BID ADDENDUM NO. 1

May 21st, 2026
Corning-Painted Post ASD
2026 Carder Crawl Space Encapsulation
2649-163

SED #57-10-00-01-0-005-028 – Frederick Carder

1 CRAWL SPACE DRAIN TILE DETAIL
1" = 1'-0"

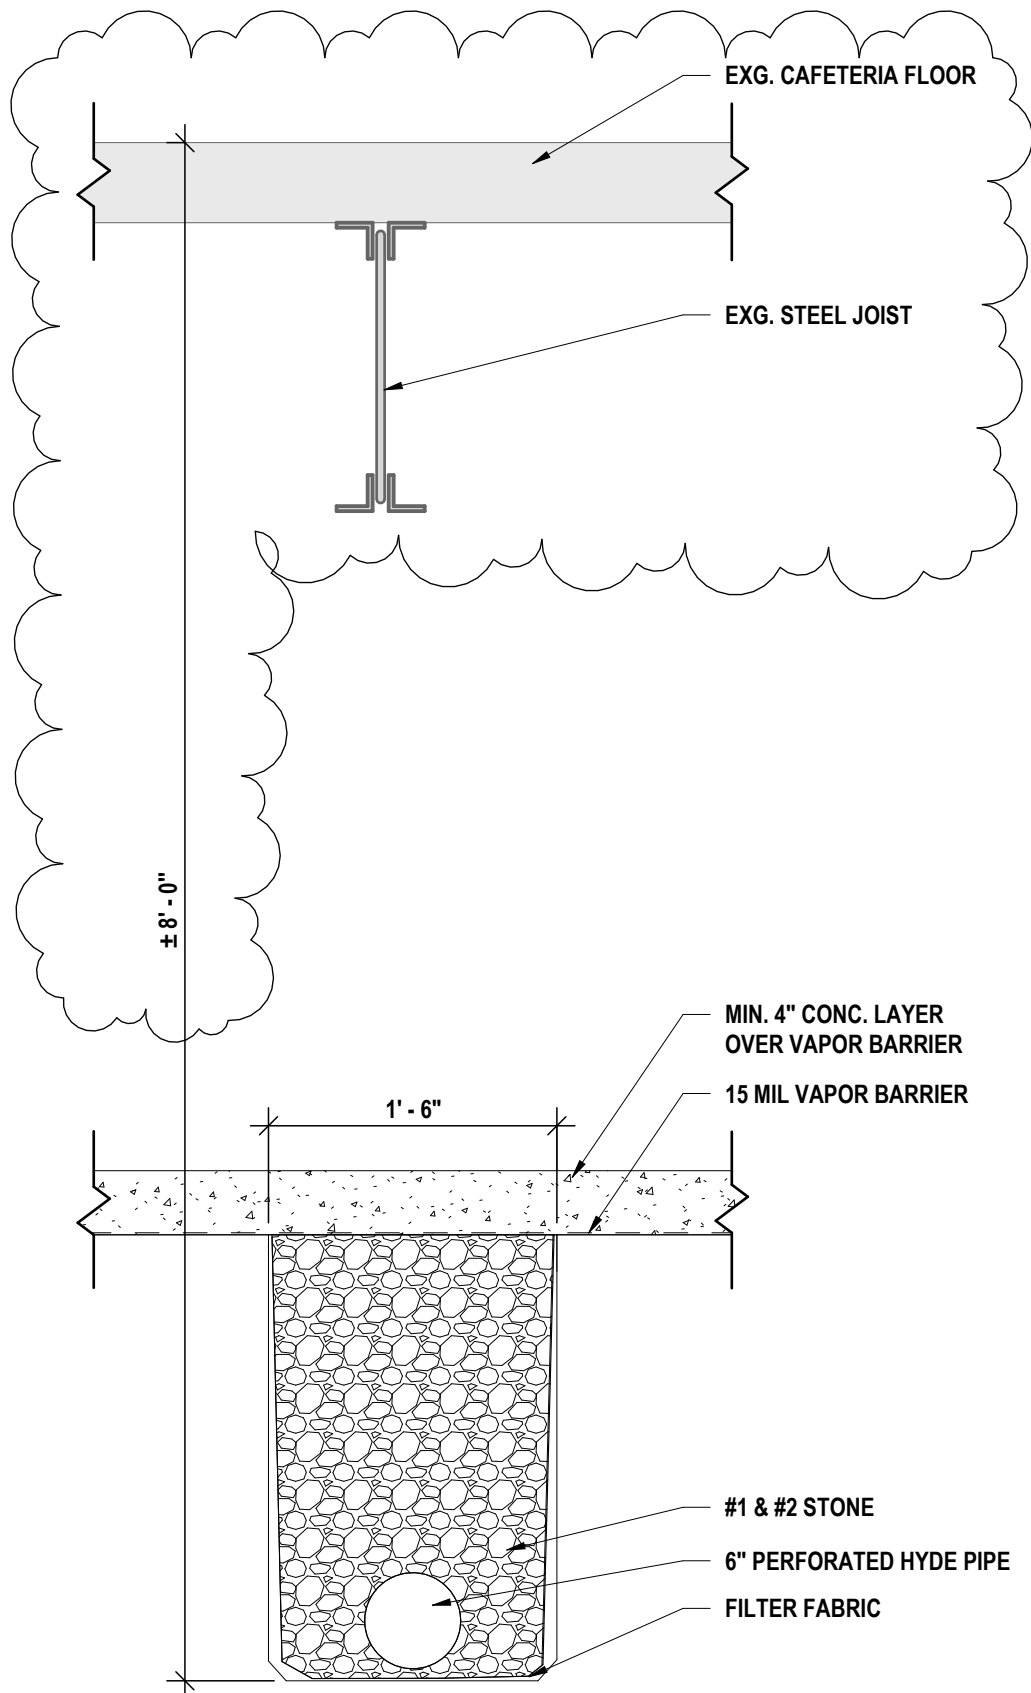
ITEM AD1-6 Refer to Drawings FC-A1.1 CRAWL SPACE PLAN - AREA A

AMEND View #4 as clouded in drawing AD1-A1 issued with this addendum

1 PARTIAL CRAWL SPACE PLAN - AREA A
 1/8" = 1'-0"

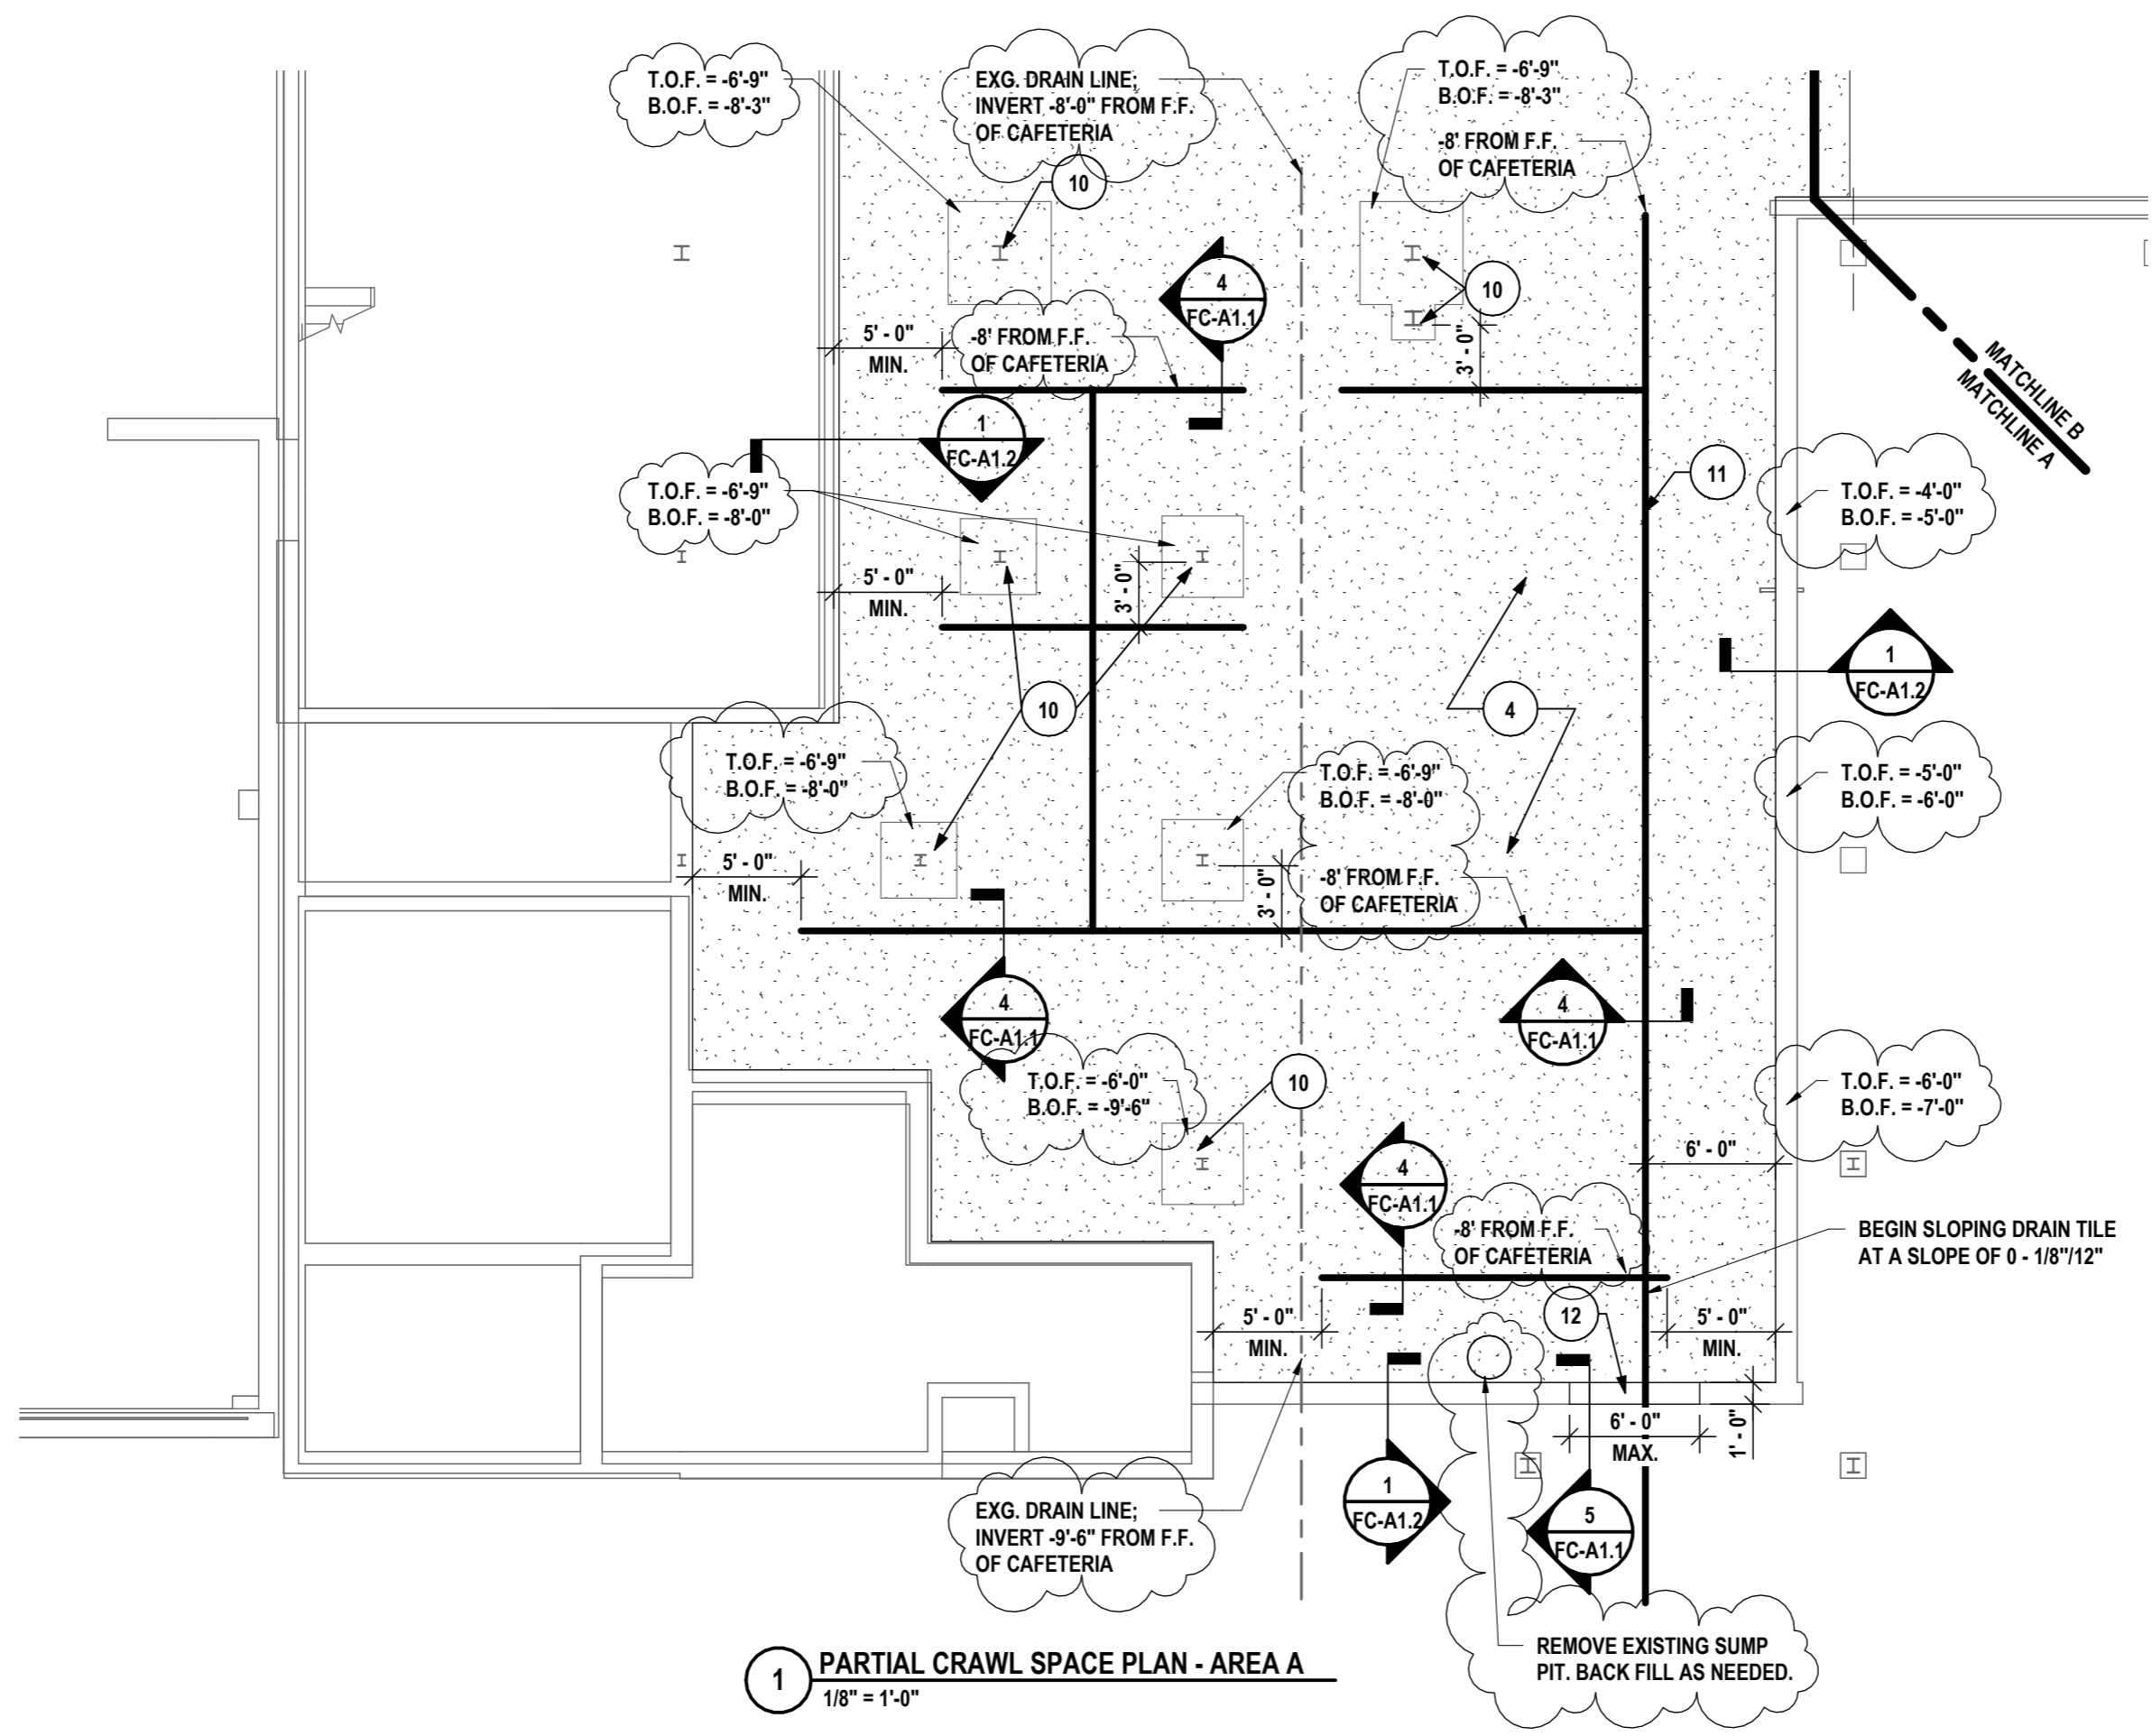
ITEM AD1-4 Refer to Drawings FC-A1.1 CRAWL SPACE PLAN - AREA A

AMEND View #3 crawl space under Cafeteria as clouded in drawing AD1-A2 issued with this addendum

ADD Plan Note #P2 to View #1 which reads “DISCONNECT AND REMOVE EXISTING SUMP PUMP. REMOVE ALL WIRE, CONDUIT, RACEWAY, BOXES AND SUPPORTS COMPLETE BACK TO SOURCE.”. Refer to drawing AD1-A2 for location of existing Sump Pump.

1 GYMNASIUM CRAWL SPACE PLAN
1/8" = 1'-0"

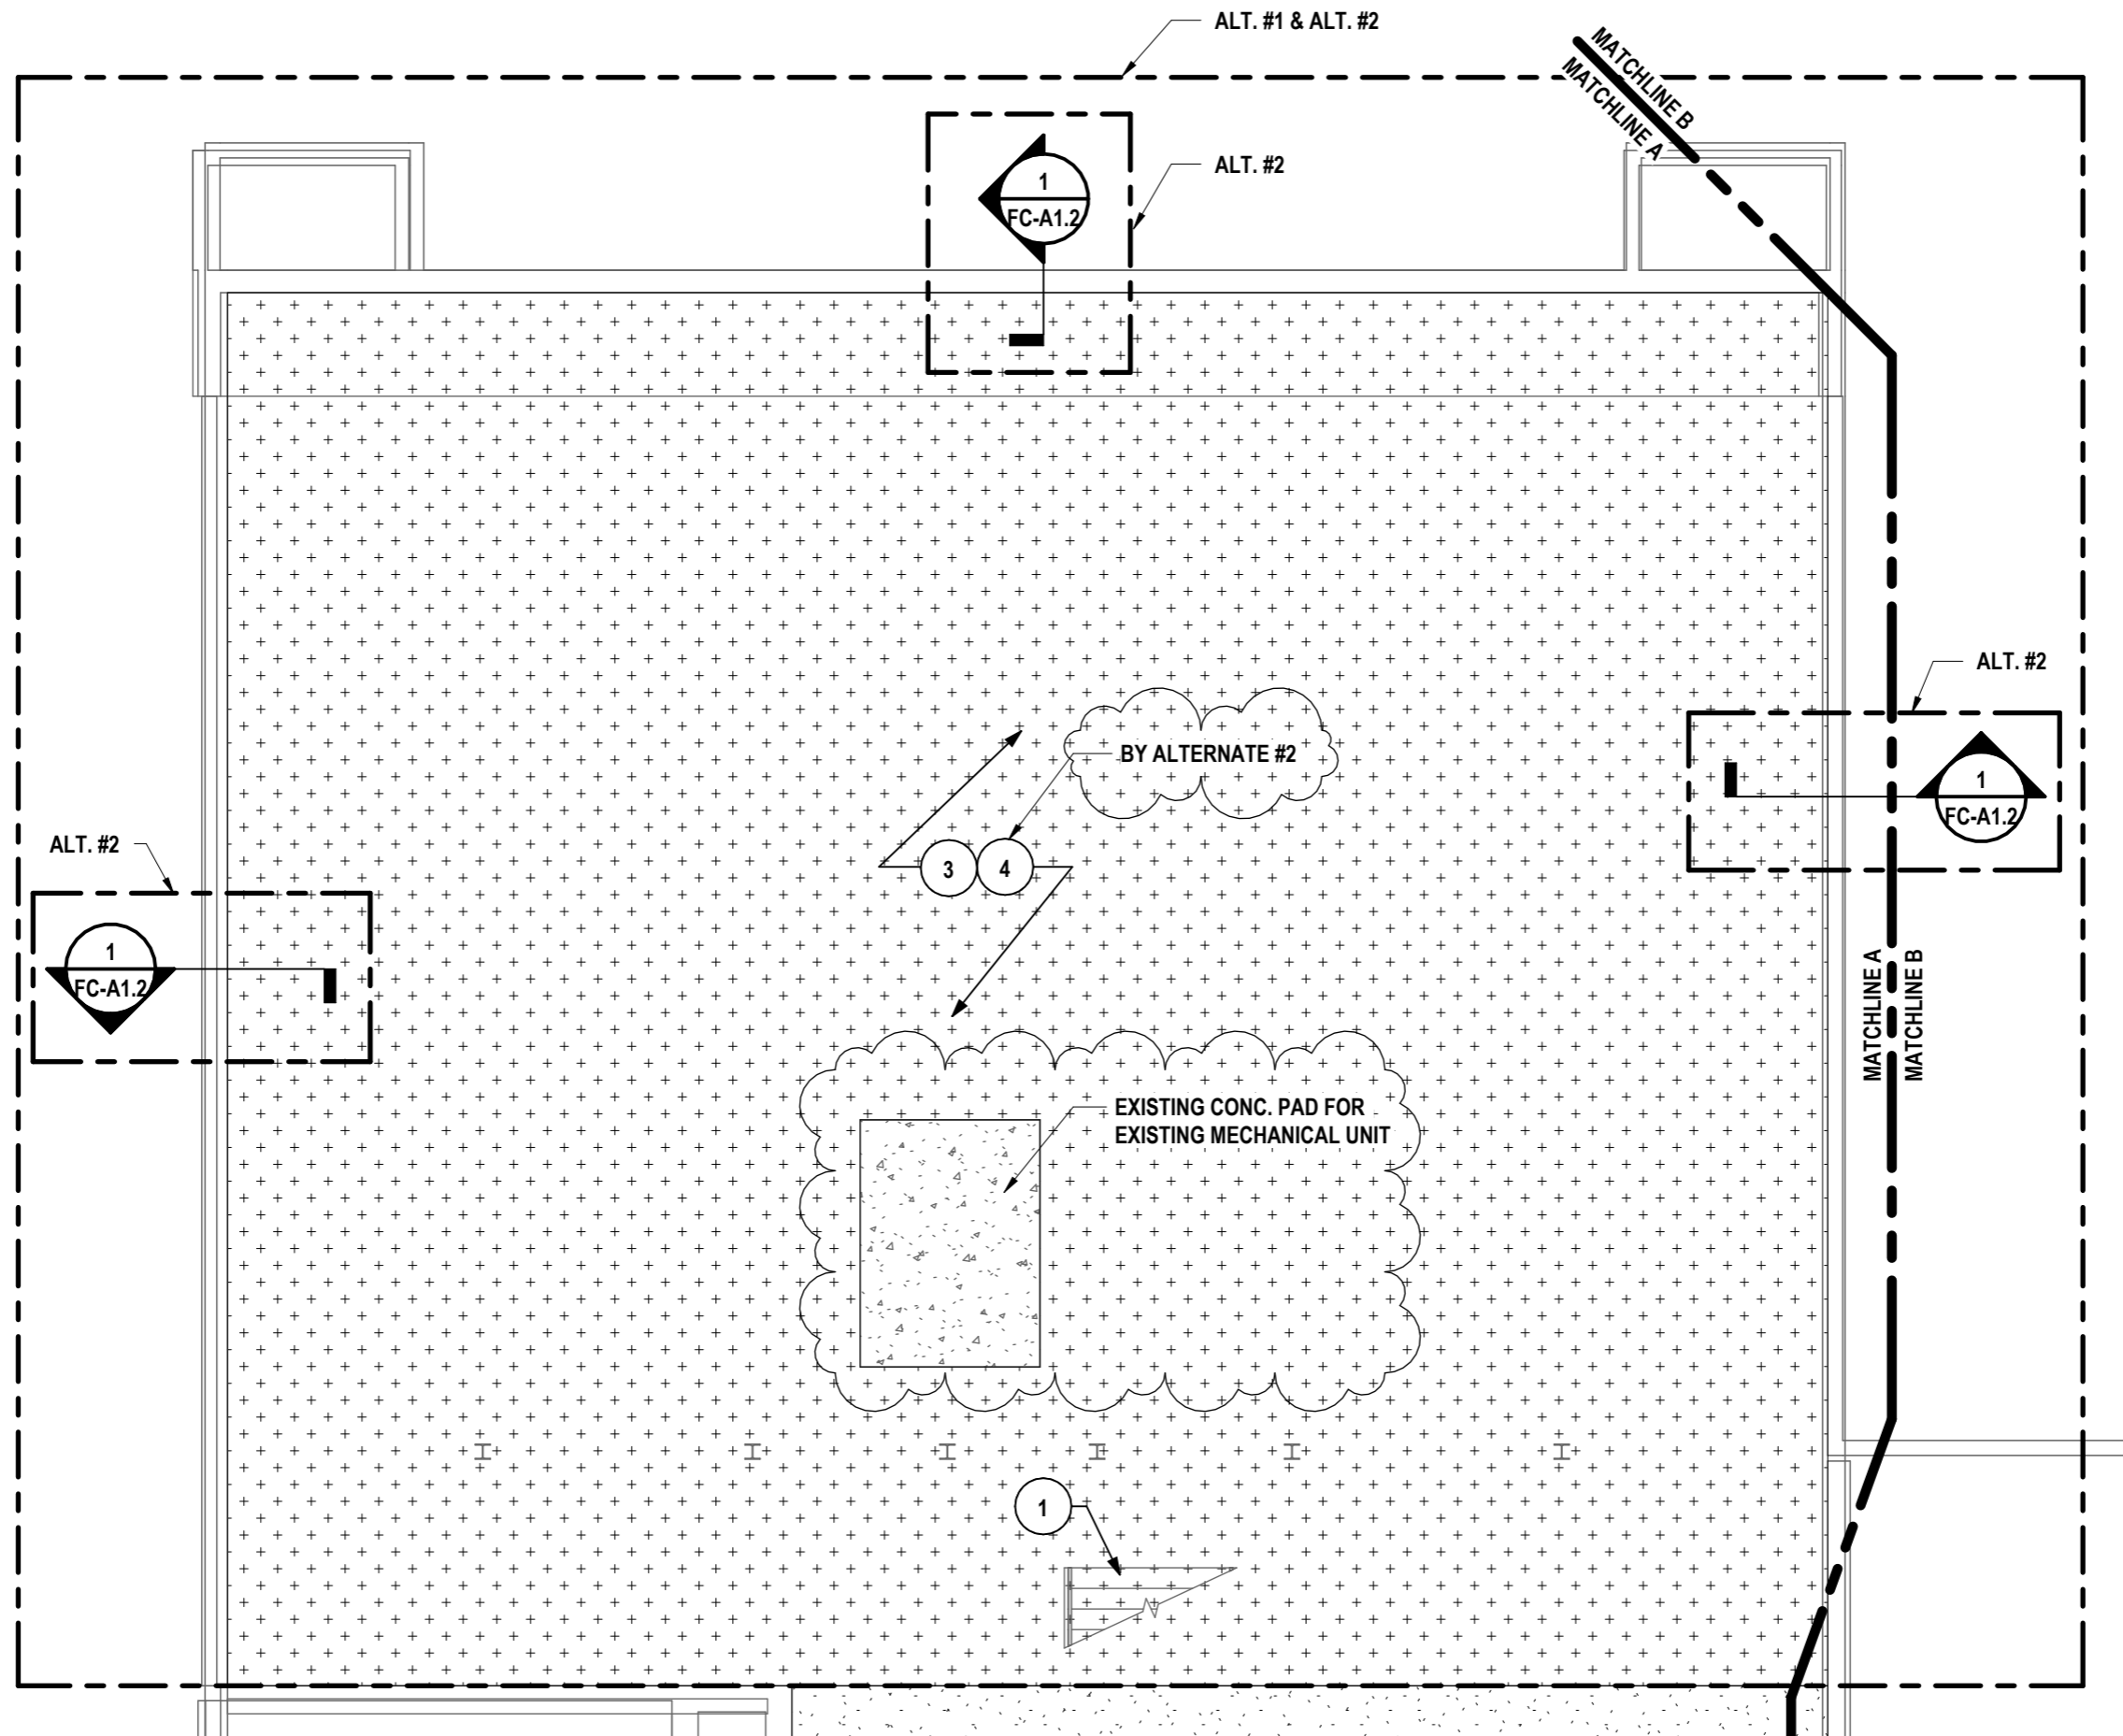
ITEM AD1-5 Refer to Drawings FC-A1.1 CRAWL SPACE PLAN - AREA A

AMEND View #3 crawl space under gymnasium as clouded in drawing AD1-A3 issued with this addendum
